Site Survey of Selected Items  
for  
Compliance with the Americans with Disabilities Act  
(ADAAG)  
and  
Title 24 of the CBC

The site survey of Pacoima Middle School was conducted on December 1, 2006 during a spot check for compliance with the Americans with Disabilities Act Guidelines (ADAAG) and Title 24 of the CBC

# Facility Name: Pacoima Middle School

Ramp to Nurse Office

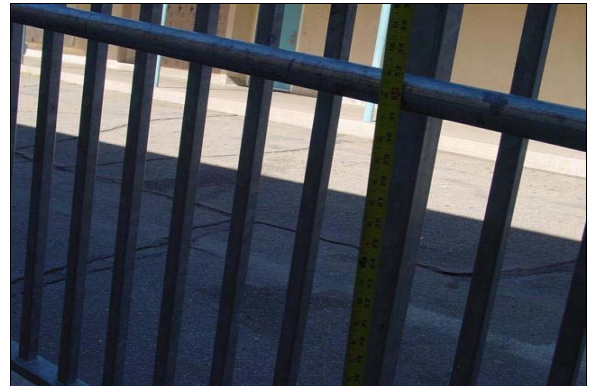
**Finding:** There are no 12-inch extensions beyond the top right and bottom of the ramp.

**Full Rec** Replace the handrails on each side of the ramp to provide a smooth and continuous gripping surface diameter between 1 1/4 inches to 1 7/8 inches, mounted at a height between 34 inches and 38 inches and shall be at a distance no less than 1 1/2 inches from the adjacent wall. The gripping surface shall be smooth and free from interruptions. The handrails shall provide 12-inch extensions, extending beyond the top and bottom of the ramp, that are parallel to the ground surface and return smoothly to the post or wall.
